**RE: Icon Samson 10 – 1 Screen Addition
13120 Central SE
Grading and Drainage Plan
Engineers Stamp Date 5/20/13 (L22D033A)**

Based upon the information provided in your submittal received 5/20/16, this plan is approved for building Permit.

PROPOSED
GRADING &
DRAINAGE
PLAN

C1.00
OF

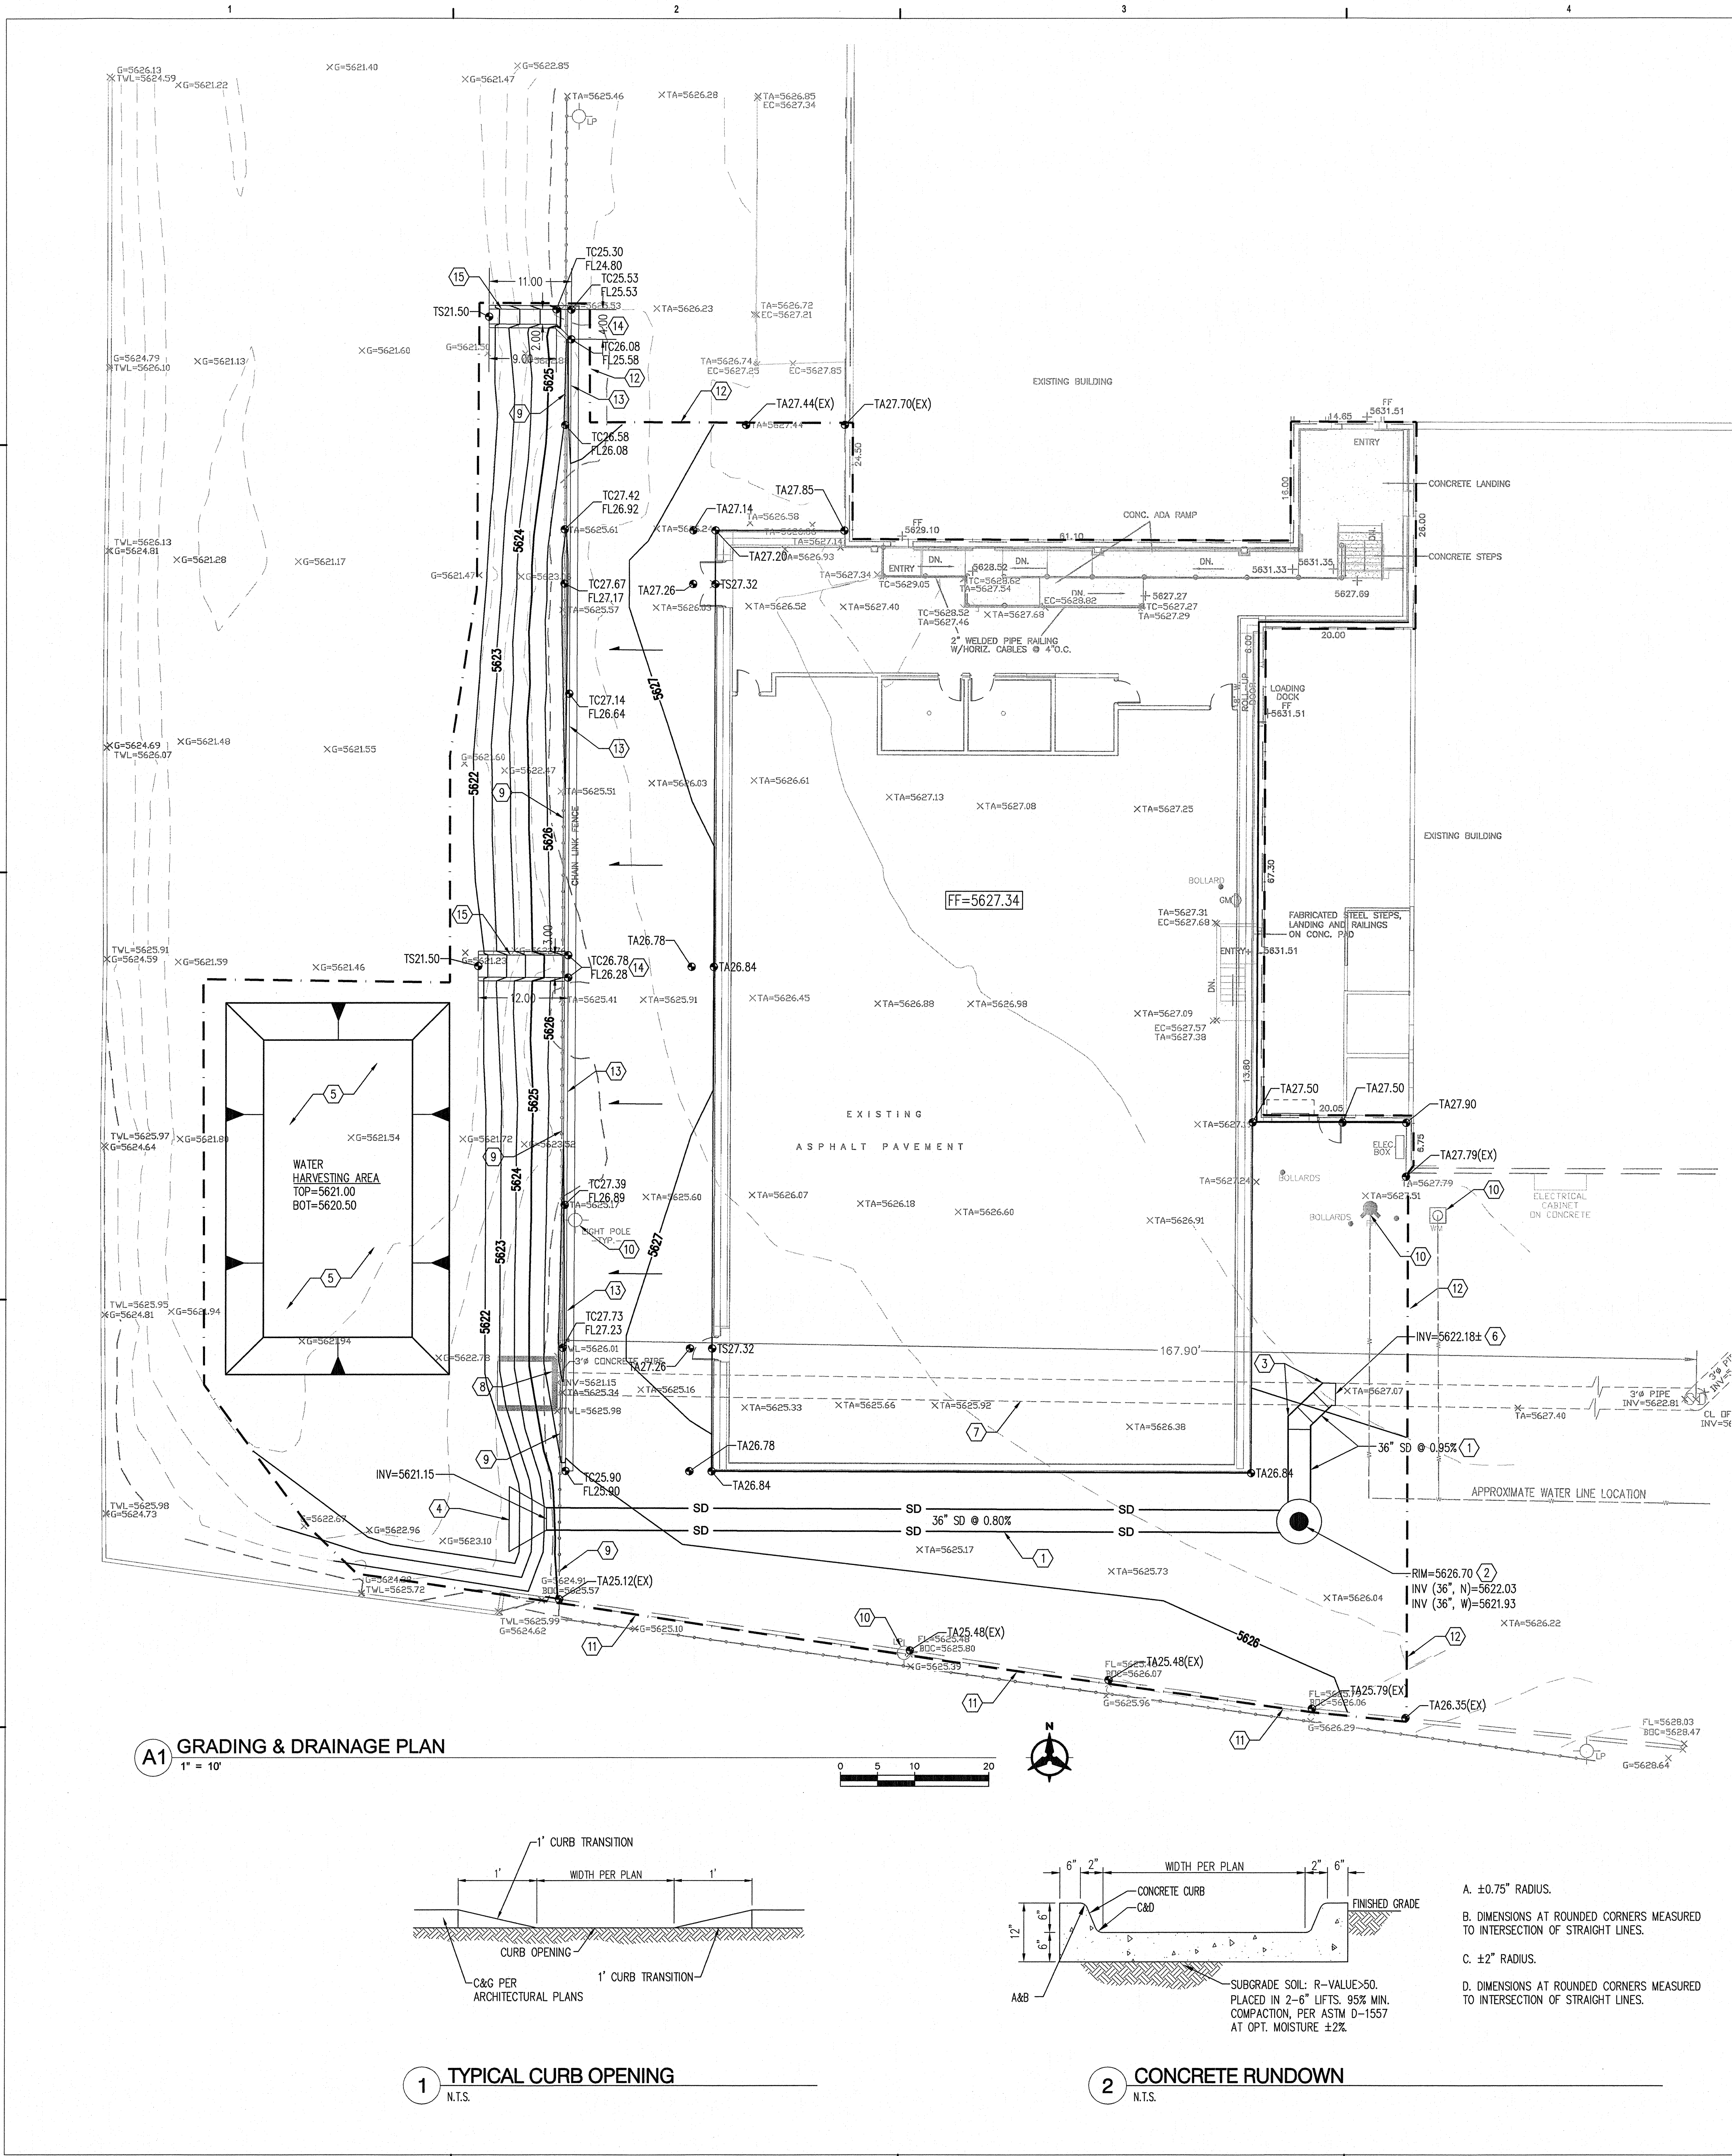
Prior to Certificate of Occupancy release, Engineer Certification per the DPM checklist will be required. Also, before CO is accepted provide erosion protection at the bottom of the pond where rundowns are located.
